COUNCIL ASSESSMENT REPORT

Panel Reference	PPSSCC-229
DA Number	DA 1302/2020/JP/A
LGA	The Hills Shire Council
Proposed Development	Division 8.2 Review of Determination of DA 1302/2020/JP for a Commercial Development Including Offices, Showroom, Food and Drink Premises and Basement Carpark.
Street Address	Lot 4026 DP 873565, 8 Solent Circuit Norwest
Applicant	EBH Investments Pty Limited
Consultant/s	Calibre Consulting Stantec Gennaoui Consulting Bates Smart Australis Tree Management WT Partnership Arcadia SCP Consulting JK Geotechnics JK Environments McKenzie Group Morris Goding Access Consulting Renzo Tonin Cermak Peterka Petersen MRA Consulting Group DSA Consulting
Date of DA lodgement	09 March 2021
Number of Submissions	Nil
Recommendation	Approval, subject to conditions
Regional Development Criteria (Schedule 7 of the SEPP (State and Regional Development) 2011	CIV exceeding \$30 million (\$117,040,000)
List of all relevant s4.15(1)(a) matters	<ul style="list-style-type: none"> • State Environmental Planning Policy (State and Regional Development) 2011 • State Environmental Planning Policy Infrastructure 2007 • State Environmental Planning Policy No 55 — Remediation of Land • The

Figure 1: Diagram indicating variation to front setbacks for Building A

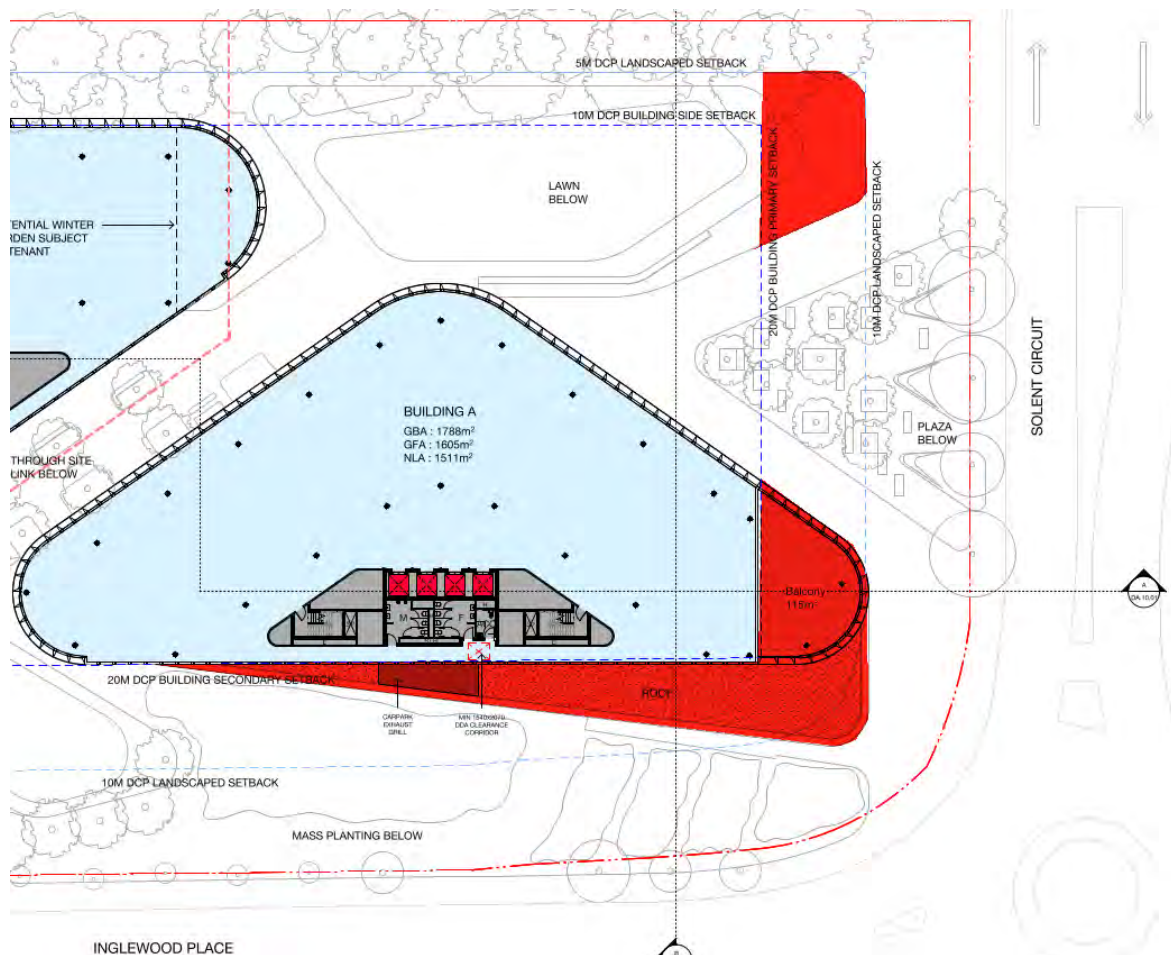
The DCP requires a 20m front setback to the primary road frontage and a 20m setback to the secondary road frontage. The subject proposal includes a 6.7m setback at the splayed corner of Solent Circuit (primary frontage) and Inglewood Place (secondary frontage) and a 10m setback for the upper ground lawn/internal car park entrance/café structure. The variation to the front setbacks are highlighted in red in the below figure:

Comment:

Figure 3: Landscape Design Diagram

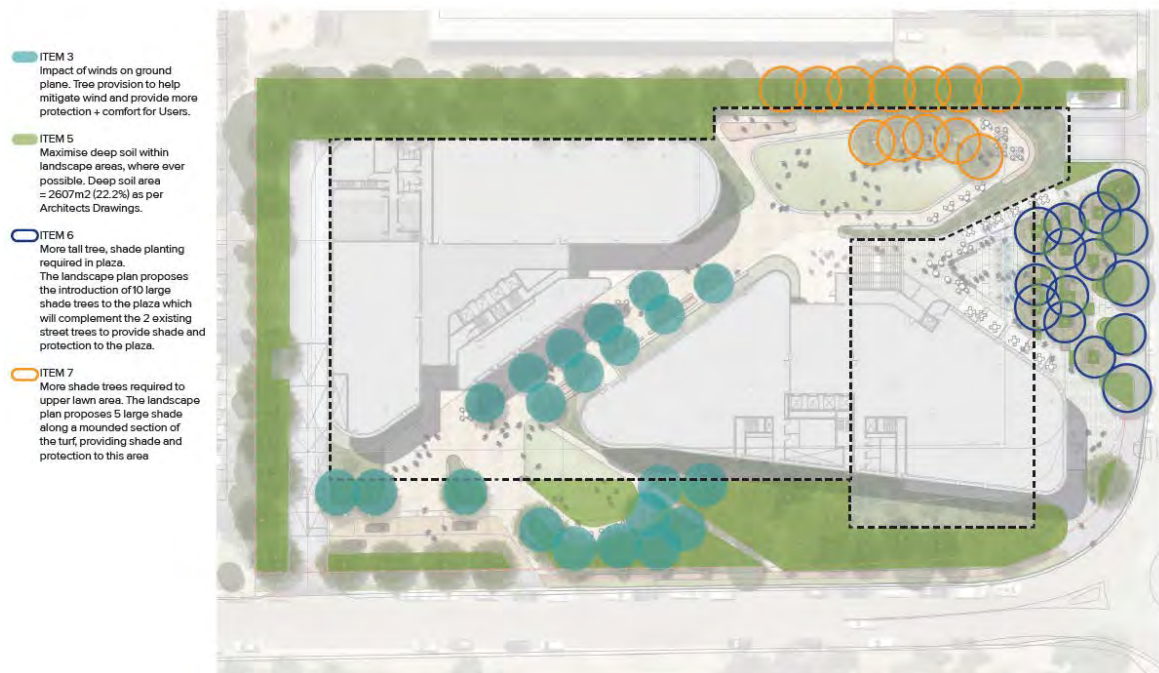
With respect to the elevated lawn and café underneath, the variation only occurs to approximately 40m² Gross Floor Area of the café. Despite the variation, the proposal allows for a built form that encloses the plaza area and results in a well-designed and integrated public domain for a work environment. The landscape plans submitted indicate substantial

deep soil areas and tall canopy trees would be planted within the street frontages to provide for an attractive landscaped setting. Refer figure 3 below.

It has been demonstrated that the proposed development can achieve an attractive streetscape and substantial areas for landscaping and screen planting, provides a safe, desirable and aesthetically pleasing working environment whilst maintaining the amenity of adjoining properties. In this regard, the variation to the front setbacks control is supported.
